**MEMORANDUM****TO:** District of Columbia Zoning Commission**FROM:**  Jennifer Steingasser, Deputy Director Development Review & Historic Preservation**DATE:** June 6, 2014**SUBJECT: ZC 14-02: Hearing Report –Barry Farm
First Stage PUD and Related Map Amendment**

Map 3 - Parcel Map

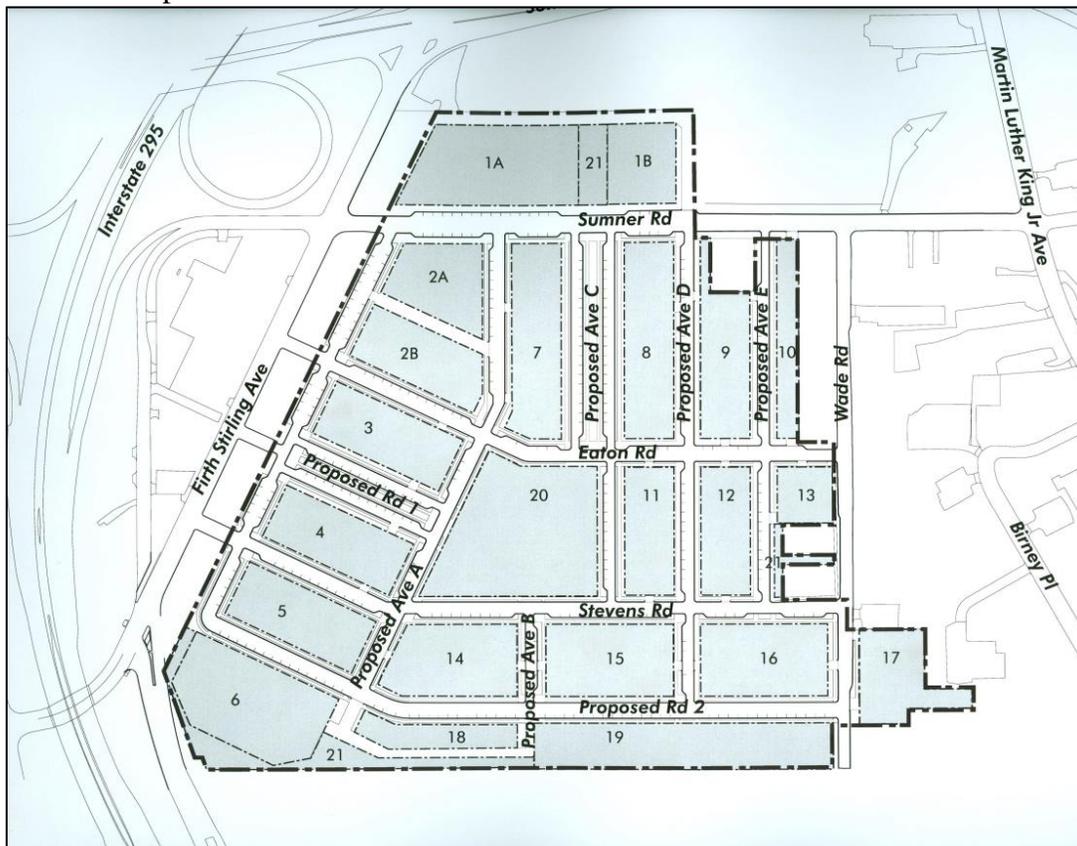
Subsequent to set down, in response to concerns raised, the Applicant revised the site plan layout considerably, and would now be subdivided into twenty-one (21) parcels (Map 3)¹. The development would retain the existing streets, although somewhat realigned, and introduce new approximately east-west and north-south streets to create a nearly grid pattern with smaller blocks than at present, and as previously proposed. The smaller blocks would provide more connectivity within the community and provide security within the development by providing better views and more eyes on the street.

Map 5 – Proposed Zoning

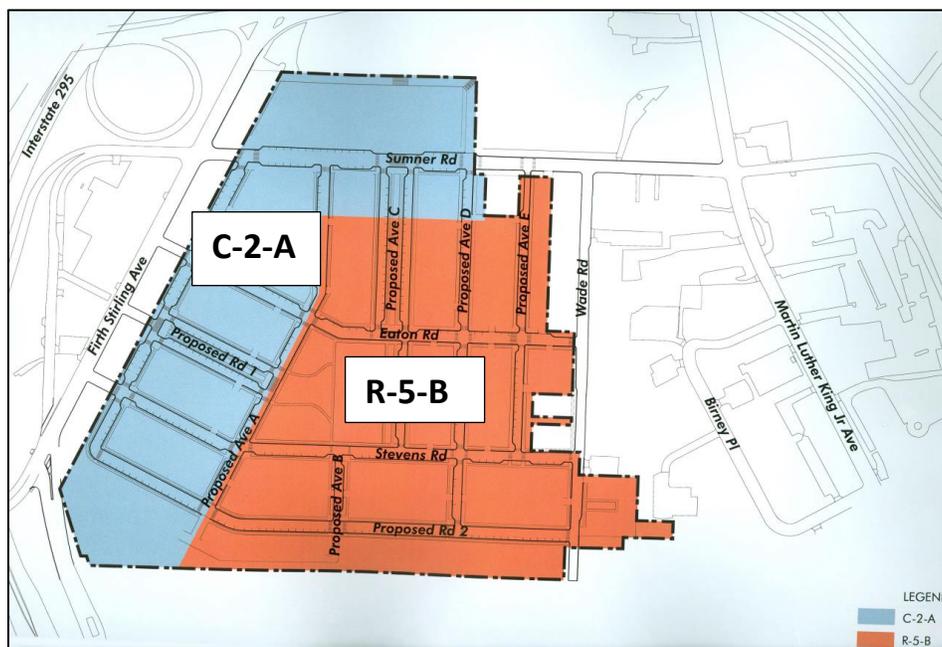
As shown on the map below, the C-2-A zone is proposed for Parcels 1A-6 and portions of Parcels 7, 8, 9, and 21, which are intended for apartments and mixed use buildings with retail and service uses on the ground floor; while R-5-B is proposed for the remainder of the property slated for townhouses and flats to a height of up to 48 feet.

The Zoning Tabulation sheets show the building on Parcel 8 would be at a maximum 73 feet, eight feet over the permitted 65 feet. The applicant has been advised to provide additional justification for this relief.
